CHAMPIONS QUARRY

Minor Operational Changes Modification (PA 09_0080 MOD 2)

Environmental Assessment Report

Figure 2: Location of Internal Haul Road

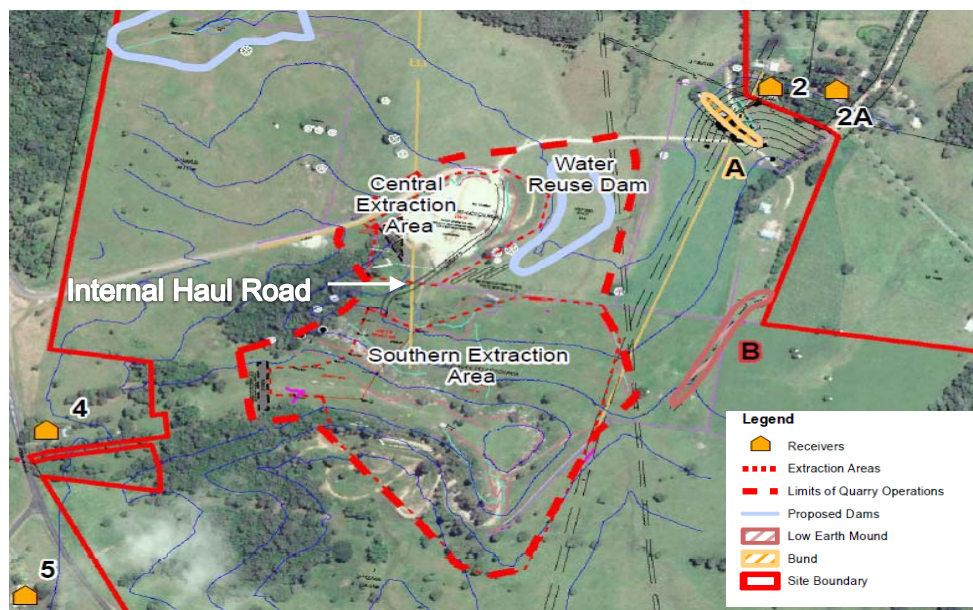
The sealing of the internal haul road between the Central and Southern Extraction Areas was proposed as part of the dust control measures contained in the 2009 project application and EA. Champions has stated that sealing the haul road is impractical as heavy machinery would rip up the seal, resulting in potential contamination of product, and has requested that watering the haul road be allowed as an alternative.

As noted in correspondence dated 13 January 2015 from the Department to Champions Quarry, the Department has previously accepted that sealing the internal haul road would be of little benefit and would likely be damaged by heavy vehicles. The key issue is whether the sealing of the internal haul road is necessary for the quarry to meet air quality criteria and whether watering of the haul road is a satisfactory alternative. As identified in the 2009 EA (see Table C1: Emissions Estimation in the Air Quality Assessment (ERM, November 2009)), the air quality modelling assumed that internal haulage would be on unsealed roads. There were also a number of other factors which led to the model and its predictions being conservative. Nonetheless, the Air Quality Assessment predicted that the quarry could meet all air quality criteria at all private residences. Champions is currently complying with air quality criteria, as detailed in its 2015 and 2016 Annual Reviews.

The Department considers that watering of internal haul roads at a rate of 2 litres per m² per minute is an acceptable method of controlling dust from haul roads. The Department is satisfied that watering the internal haul road between the Central and Southern Extraction Areas as an alternative to sealing the road is a satisfactory and practical method of controlling dust.

**Figure 3: Approved Conceptual Biodiversity Offset Areas and Protected Revegetation Areas**

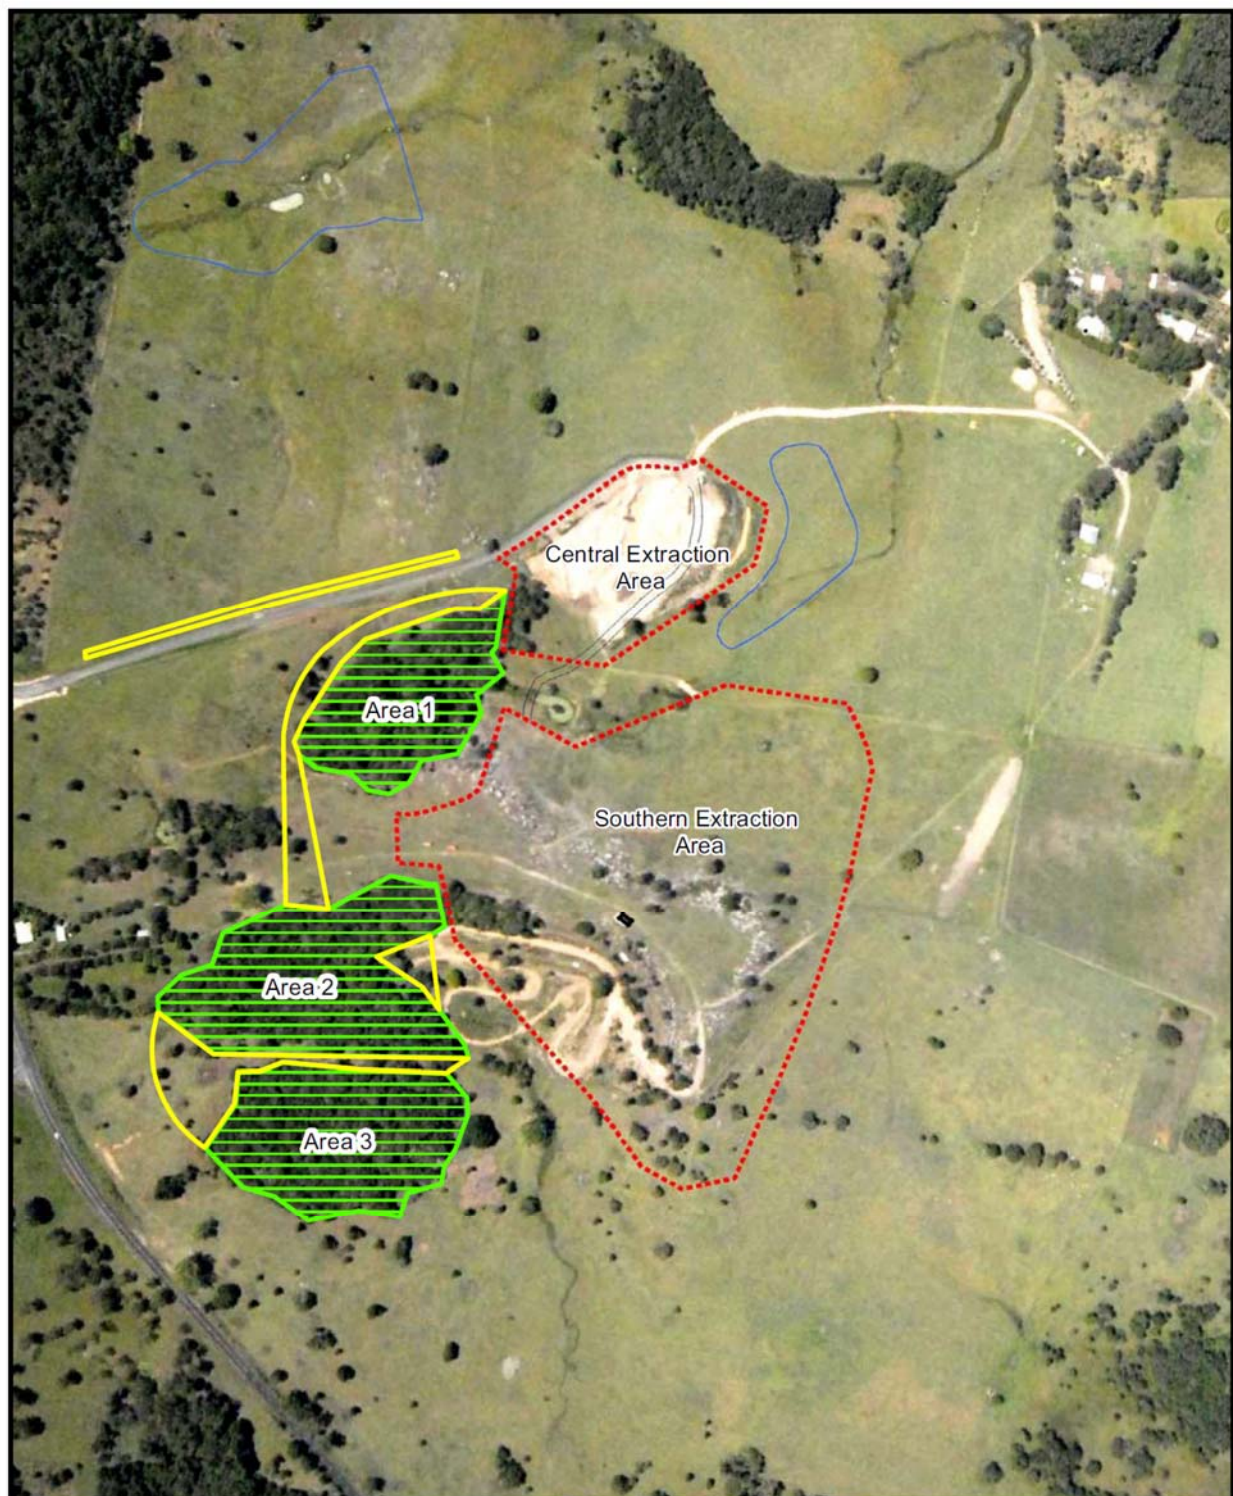
However, in reviewing the revised boundaries overlaid on the aerial photo (see **Figure 3**), it can be seen that Champion's revised boundaries would result in less high density/quality vegetation and a greater area of lower density vegetation in the proposed Biodiversity Areas 1, 2 and 3. Conversely, the proposed Protected Revegetation Area would contain high density/quality vegetation and less low density vegetation. This is contrary to the intent of the offset areas and is inconsistent with Champions' claim that the revised boundaries are in part the result of ground-truthing current vegetation.

During discussions with Champions it was confirmed that the revised boundaries for the offset areas were also based on its proposal to provide offset areas that could be efficiently fenced (as stated in the modification application). In so doing, Champions proposed to make maximum use of existing fencing and to maintain a 50 metre (m) buffer between the offset areas and the quarry extraction area. Champions interpreted that providing the 50 m buffer to the offset area boundary would satisfy Schedule 3 condition 37 which requires "*that the edge of the Southern Extraction Area is setback at least 50 metres from the mapped Dry Rainforest/Lowland Rainforest EEC on site.*" The Department's position is that a 50 m buffer does not in itself satisfy condition 37 because the buffer needs to be provided to the physical edge of the mapped Dry Rainforest/Lowland Rainforest EEC.

On 6 May 2016, the Department informed Champions that it was not satisfied with the Biodiversity Offset Area boundaries as proposed in MOD 2 and requested that they be revised. On 8 August 2016, Champions provided a figure showing the revised Biodiversity Offset Areas that addressed the Department's concerns (see **Figure 5**). The Department considers that the revised Biodiversity Offset Areas and Protected Revegetation Areas now more closely reflect the conceptual areas identified in Figure 9 in Appendix 6. More of the high density/quality vegetation is now contained in the Biodiversity Offset Areas, the lower density/quality vegetation is now contained in the Protected Revegetation Areas and the minimum size requirements for each area have been either met or exceeded. In fact the proposed revised BOS results in an increase in area protected by 0.653 ha, when compared with that currently required by condition 40.
